# Product Change Notification

## TE Connectivity

**Product Change Notification:** P-21-021899

DT04-2P, -3P, -4P, -6P, -8P, -12P and DT06-2S, -3S, -4S, -6S, -8S, -12S

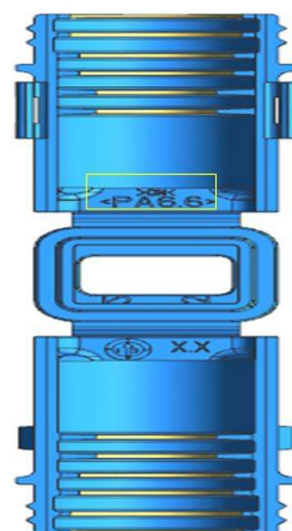
The Industrial and Commercial Transportation business unit of TE Connectivity is adding new capacity tooling for the Deutsch Cover products identified with TE Logo Trademarks for the part number(s) listed below. These PNs are TE proprietary designs, therefore considered catalog/general market product. PPAP and/or sample requests must be submitted within 14 days of PCN submission via ict-ppap-request@te.com or ePPAP system. Submission will not occur without request. If PPAP requested, disposition response is required within 14 days of submit date or it will be considered approved. Product drawing(s) will be affected with TE Logo views.

OLD WITH DEUTSCH LOGO

NEW WITH TE LOGO AND >CN< MARKING
